SUBJECT: Forwards responses to balance of plant questions & CESSAR questions. Responses will be incorporated into future FSAR amend. One oversize drawing encl. aperture card will be available in PDR.

Subject: Palo Verde Nuclear Generating Station
(PVNGS) Units 1, 2 and 3
Docket Nos. STN-50-528/529/530
File: 81-056-026; G.1.10

Reference: Letter from R. L. Tedesco, NRC, to E. E. Van Brunt, Jr.
dated June 22, 1981, subject: Request for Additional
Information - PVNGS (Reactor Systems Branch)

Palo Verde Nuclear Generating Station FSAR
RECIRCULATION SUMPS CONTAINMENT BLDG. EL. 80'	
Figure 6A-4

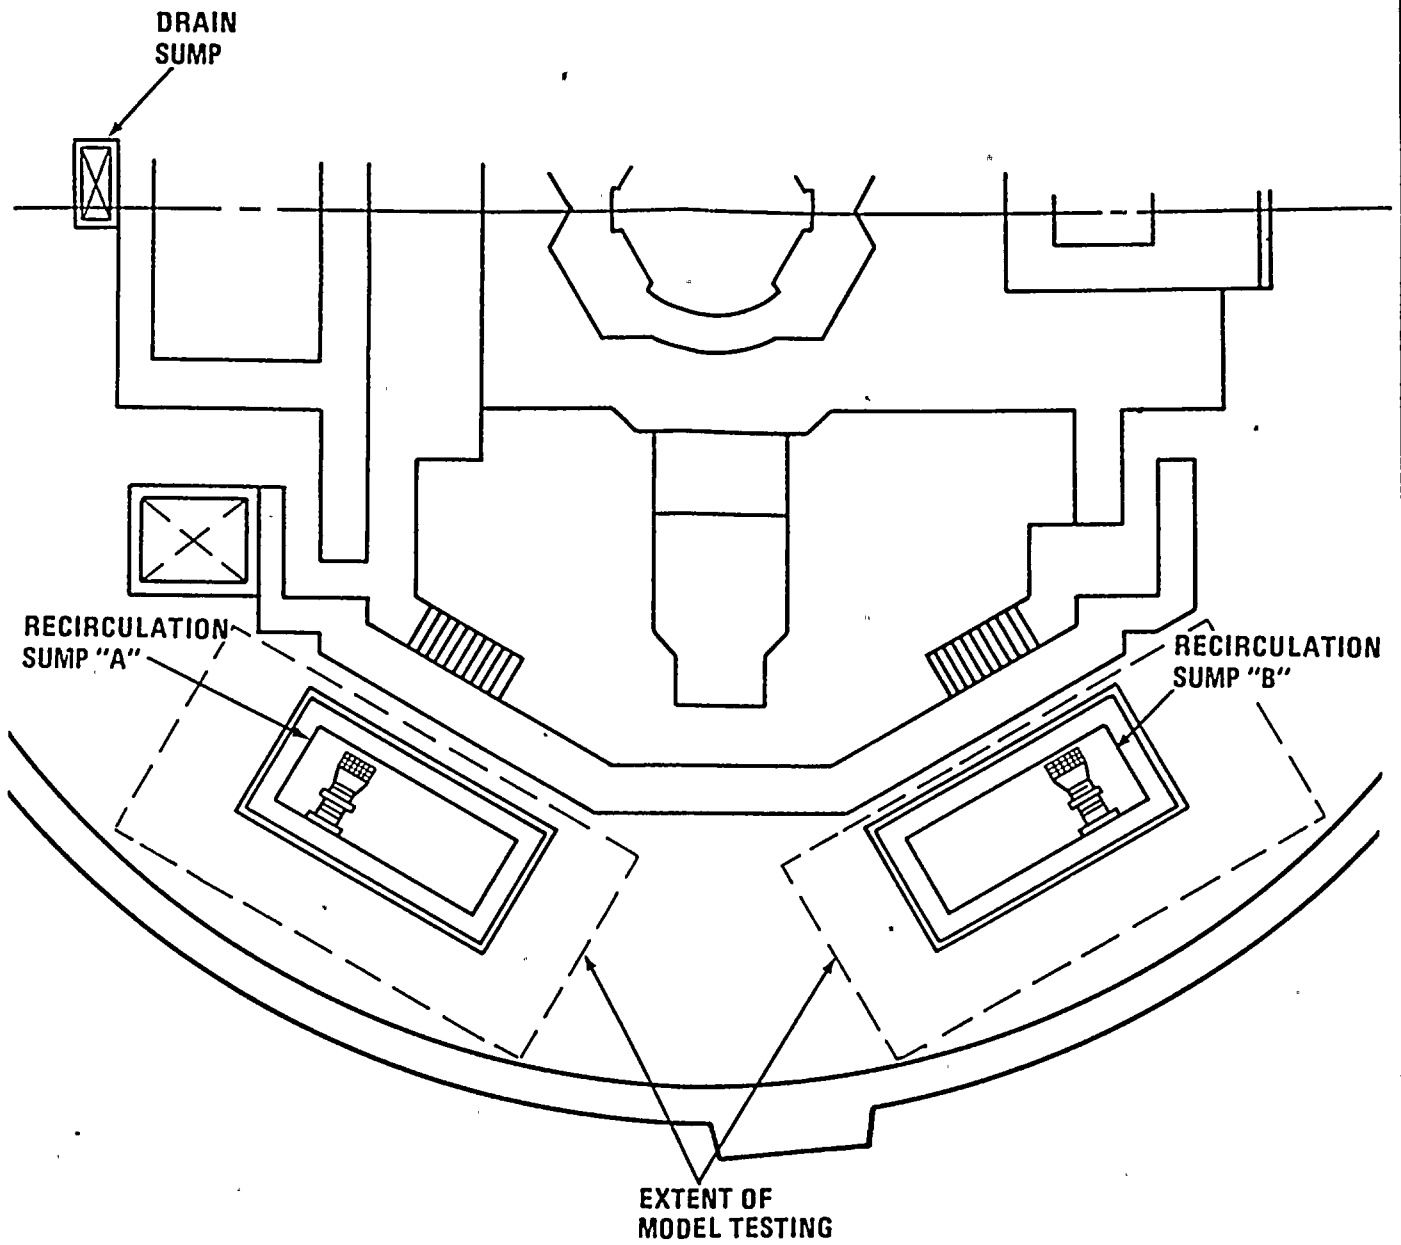
← 5.2 Figure 6A-4 shows the location of the drain sump relative to the containment sump.

needs to be installed at the suction pipe. This change will be implemented. No other changes in piping or structures ~~will be made as the tests showed them to be unnecessary.~~ The combination of this testing and the analytical calculations for head loss of piping outside the model's scope, prove that there is adequate NPSH at the safety injection pumps.

Palo Verde Nuclear Generating Station FSAR
CONTAINMENT RECIRCULATION SUMP SCREEN DETAIL	
Figure 6A-5

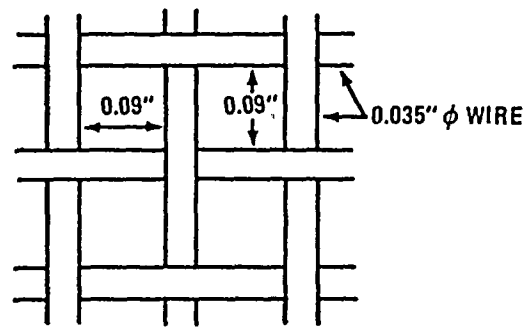
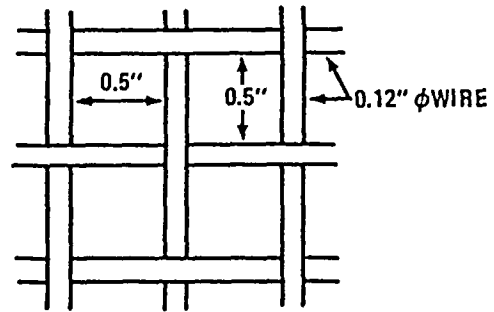
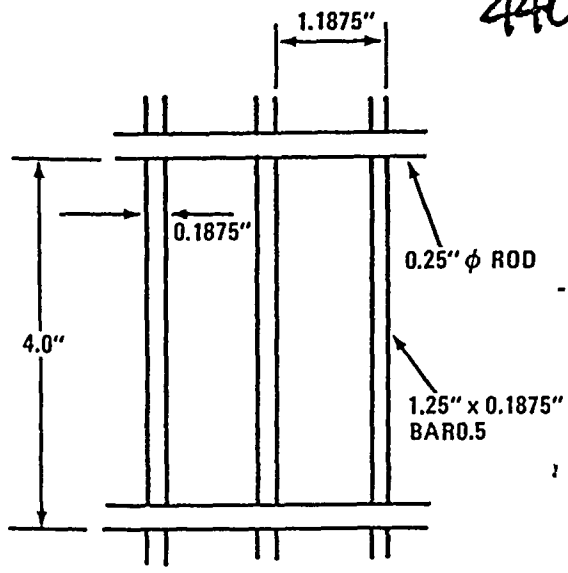
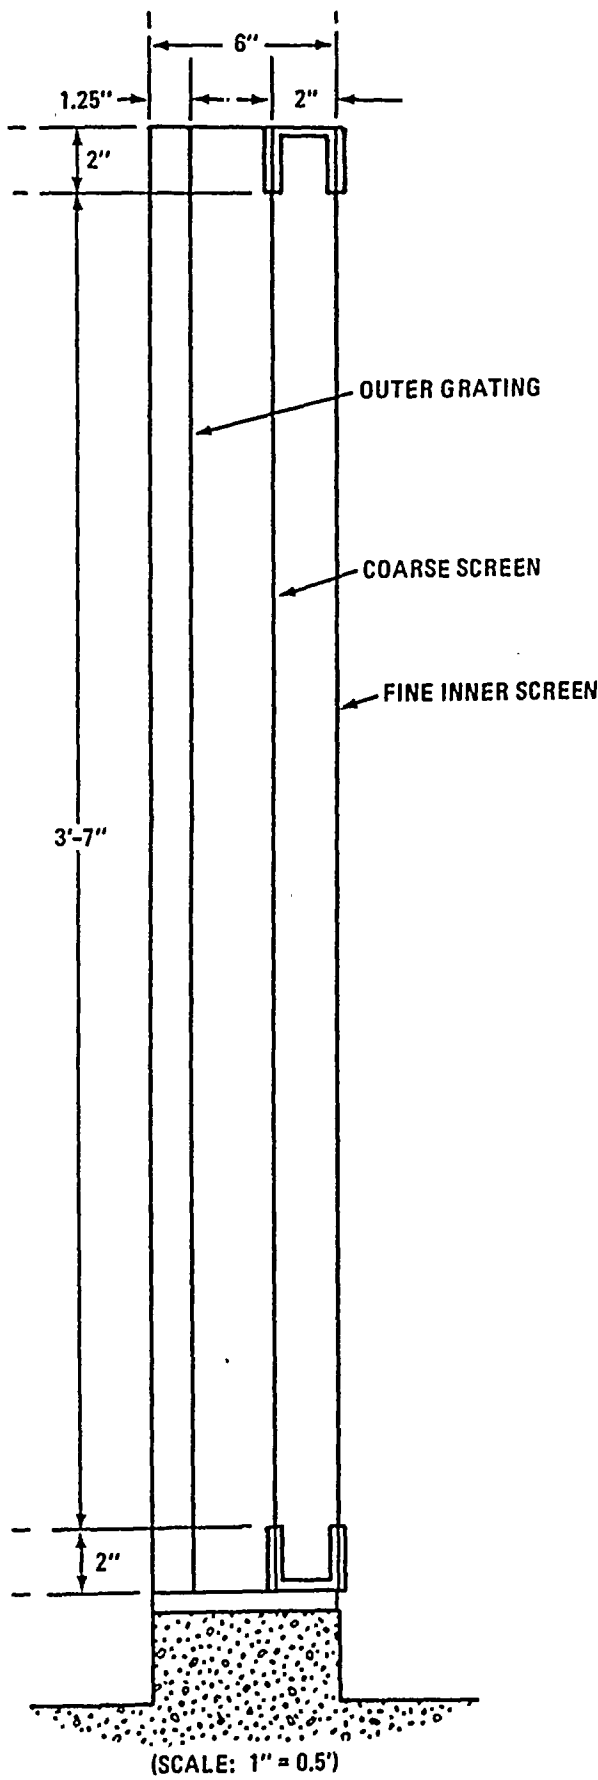
5.3.a. Figure 6A-5 provides the size of openings on the screens. No flow blockage will occur beyond the screen as all openings are larger than the minimum screen size.
